**IOWA DEPARTMENT OF TRANSPORTATION**

To Office Bridges and Structures Date December 1, 2011  
Attention All Employees Ref No. 521.1  
From Gary Novey  
Office Bridges and Structures  
Subject Revision of the English 1030A Light Pole Blister Standard.  
(CADD M0228)

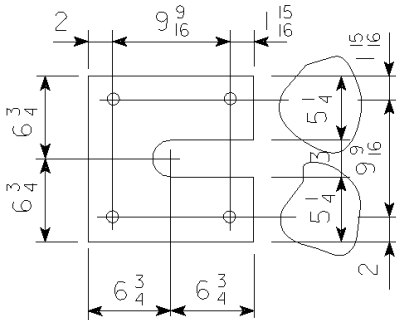
Standard 1030A was revised to locate the 3 inch slot for the conduit in the embedded plate for the bridge lighting blister. The plate detail is shown below with the encircled dimensions that were changed from 5 ¾ inches to 5 ¼ inches.
